Appendix F
Field Variance Forms

FIELD CHANGE NO.:	SEA001
PROJECT:	Former Fort Ord
PROJECT NUMBER:	739266
APPLICABLE DOCUMENT:	Final OE-15SEA1-4 Site Specific Work Plan, Programmatic Work Plan
DESCRIPTION OF CHANGE:	6-pass QC test to be performed only when entering new type of terrain.
REASON FOR CHANGE:	This QC test was being performed daily and the project geophysicists (COE and Parsons) determined that it should only be done when a new type of terrain is encountered.
RECOMMENDED RESOLUTION:	Do 6-pass QC test only when new terrain is encountered.
PRESENT AND COMPLETED WORK IMPACT:	Should slightly increase overall productivity.

**Fort Ord OE Cleanup
Flowchart
For OE with Unknown Filler
Attachment 1**

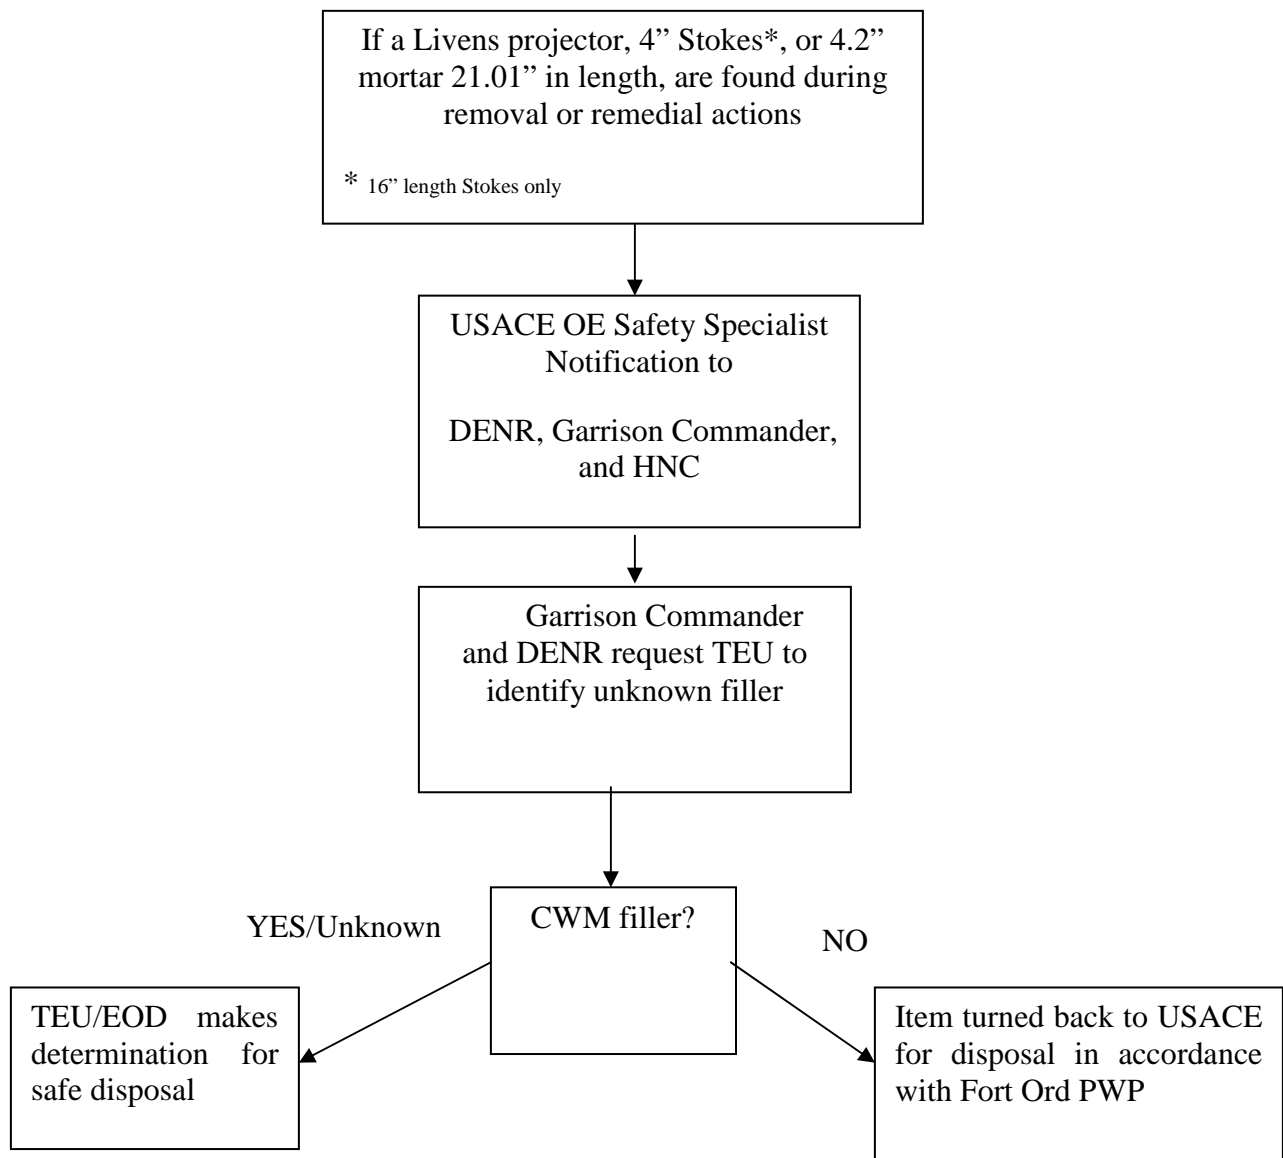
FIELD CHANGE NO.:	SEA027
PROJECT:	Former Fort Ord
PROJECT NUMBER:	739266
APPLICABLE DOCUMENT:	Programmatic Work Plan and OE-15 SEA.1-4 Site Specific Work Plan
DESCRIPTION OF CHANGE:	Add Standard Operating Procedure (SOP) G-12 for OE with Unknown Filler, see attached.
REASON FOR CHANGE:	To establish standard procedures for OJ5 with unknown filler.
RECOMMENDED RESOLUTION:	Incorporate the change as soon as possible.
PRESENT AND COMPLETED WORK IMPACT:	Minimal impact on past work, with minimal to significant impact to future work.
